This item appeared before the Design Review Committee on November 30, 2016. At that meeting issues were raised about the building design and the Committee requested that the project return to the Committee. Staff requests that the Design Review Committee receive public testimony and provide comments on the revised design.

CITY OF OAKLAND DESIGN REVIEW COMMITTEE

Case File: PLN16295
Applicant: CP VI Franklin, LLC
Address: 1314 Franklin Street
Zone: D-LM2, D-LM-3, D-LM-4

LEVEL 01

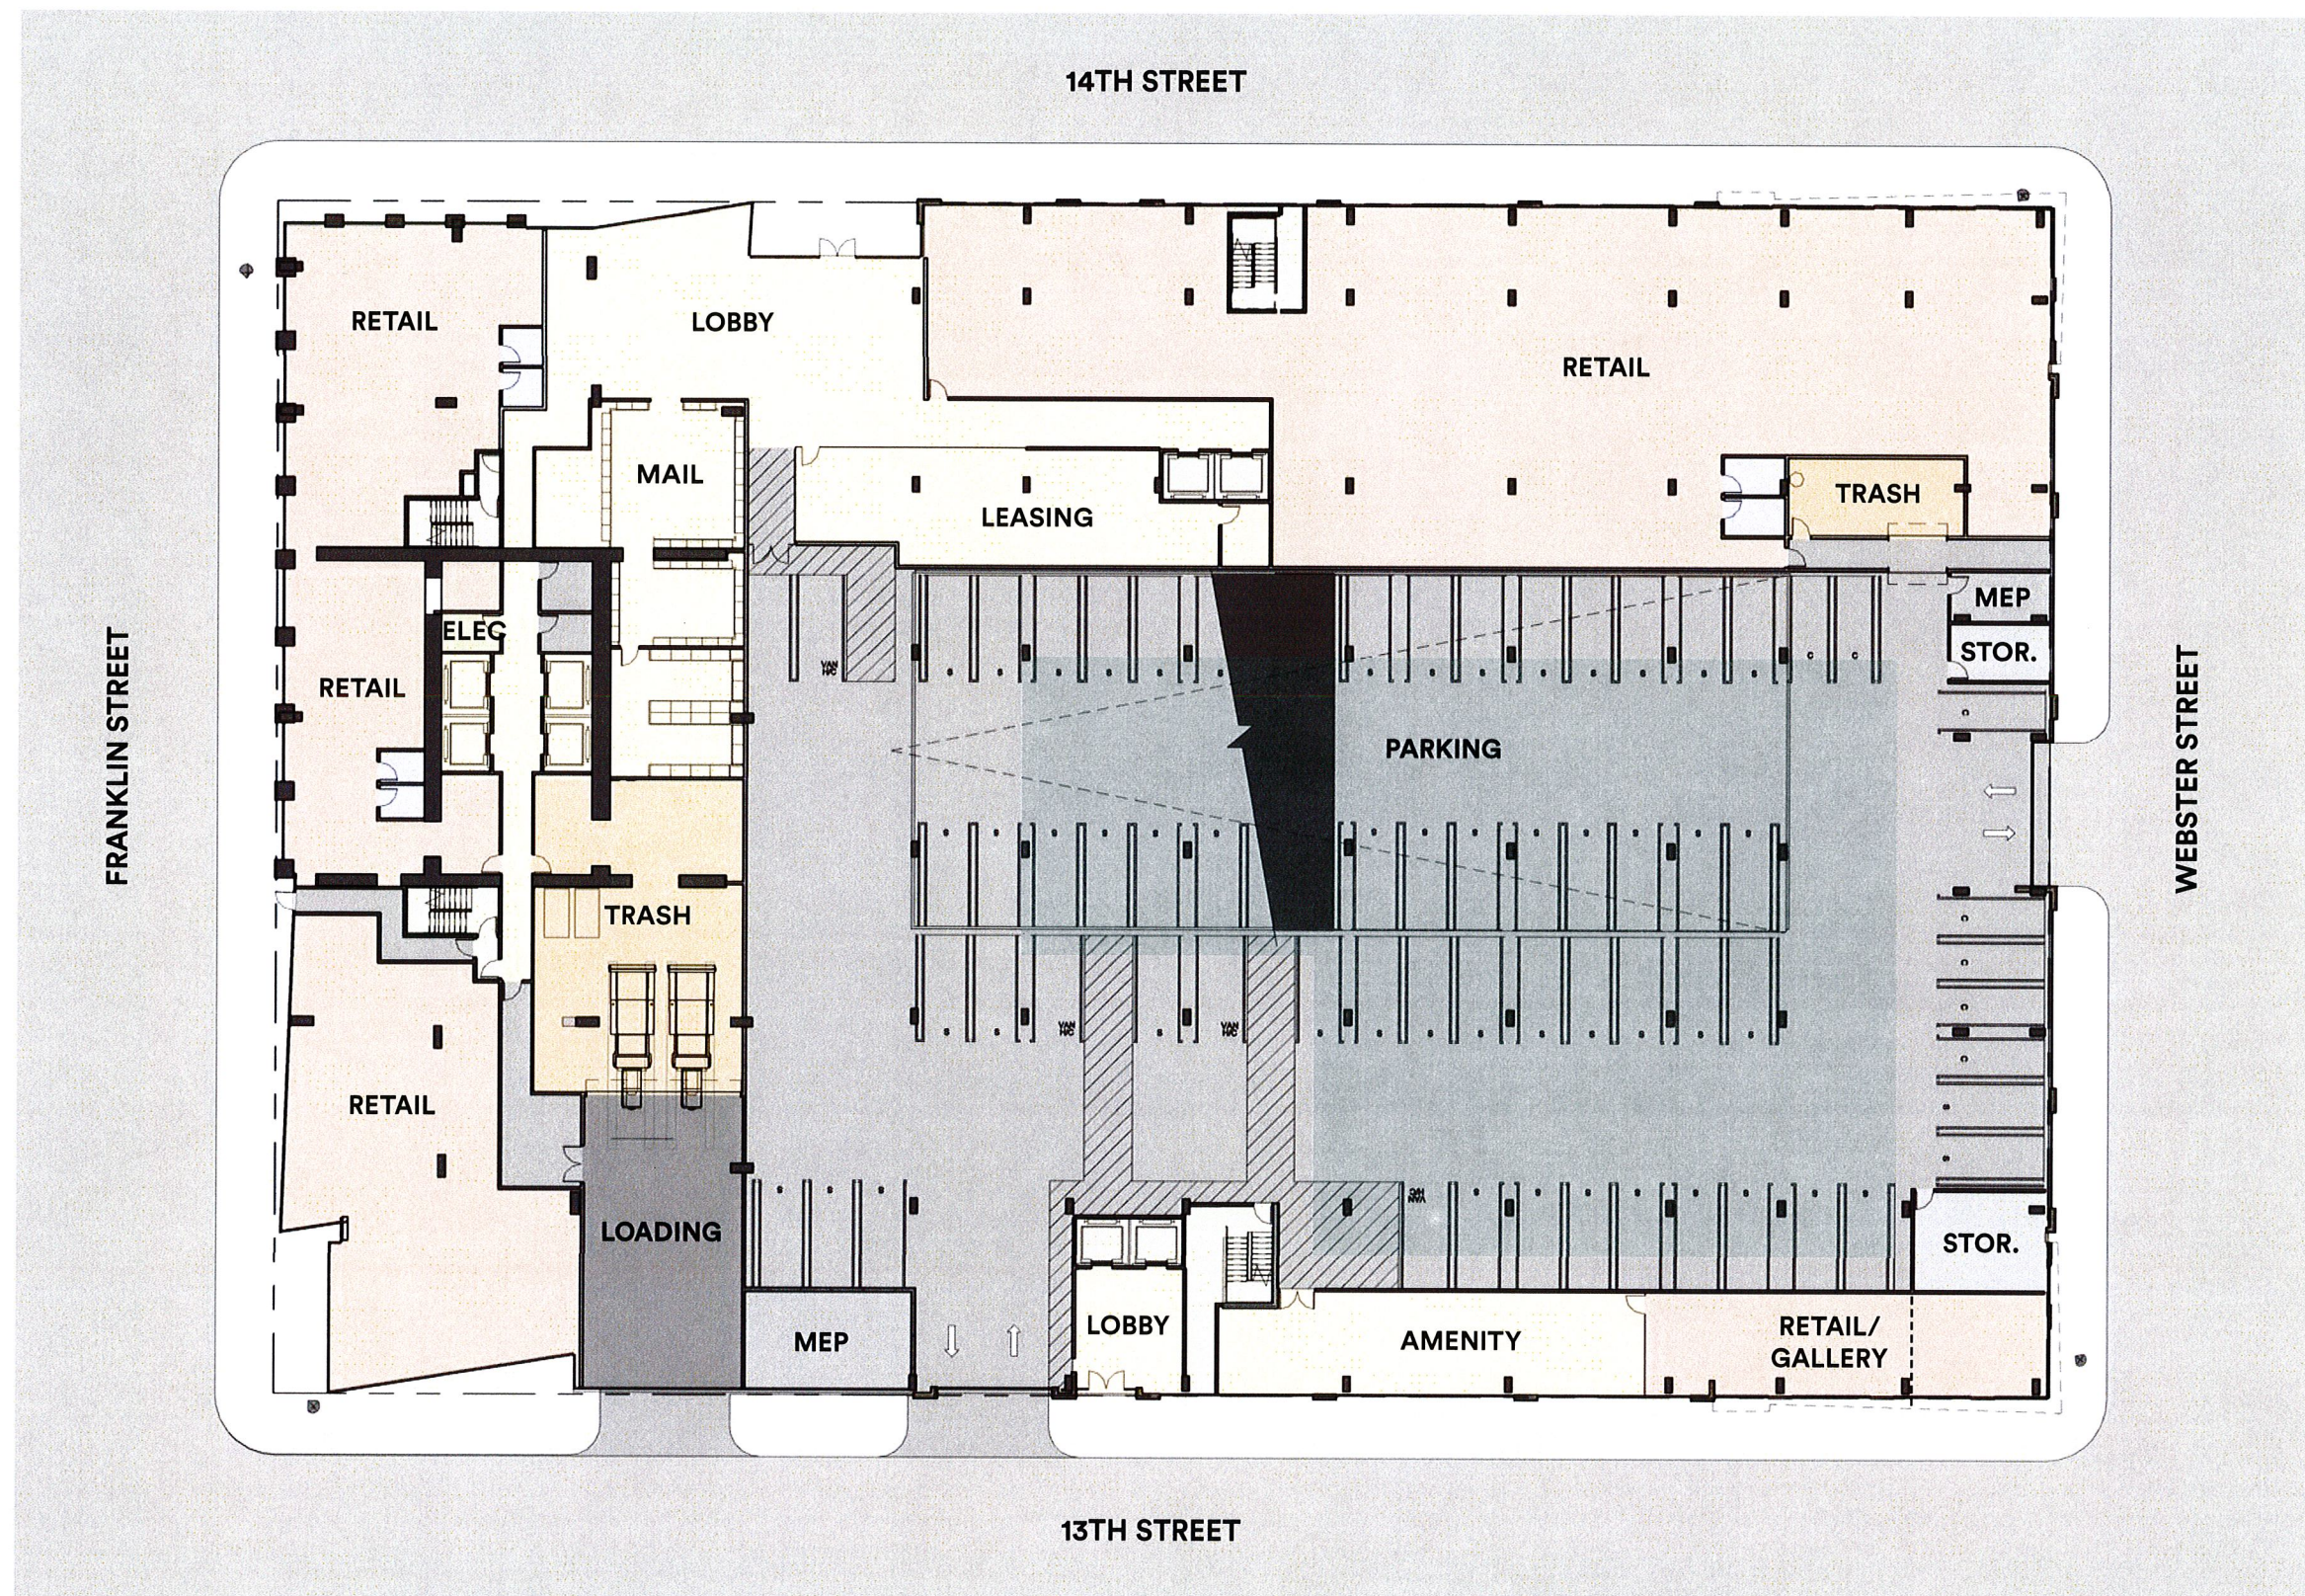
- Activate street level experience of 13th & Webster.
